Well Name: YOUNG DEEP UNIT Well Location: T18S / R32E / SEC 9 / County or Parish/State: LEA /

Type of Submission: Notice of Intent Type of Action: Plug and Abandonment

Revised Plugging Procedure

Permanent Abandonment of Federal Wells Conditions of Approval (LPC Habitat)

PLANNED P&A WELLBORE SCHEMATIC

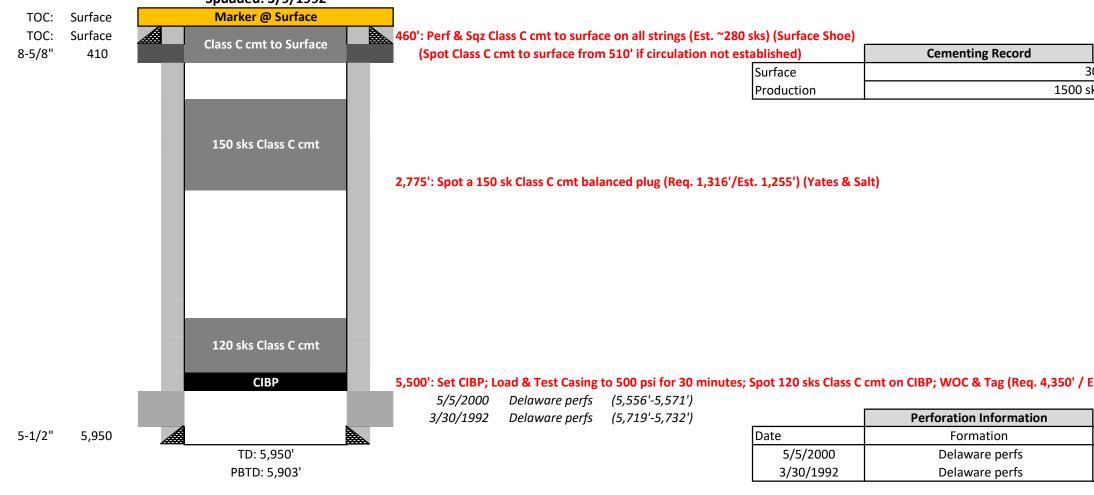
5,500': Set CIBP; Load & Test Casing to 500 psi for 30 minutes; Spot 120 sks Class C cmt on CIBP; WOC & Tag (Req. 4,350' / Est. 4,284') (Isolate Perfs, Delaware, & Grayburg)
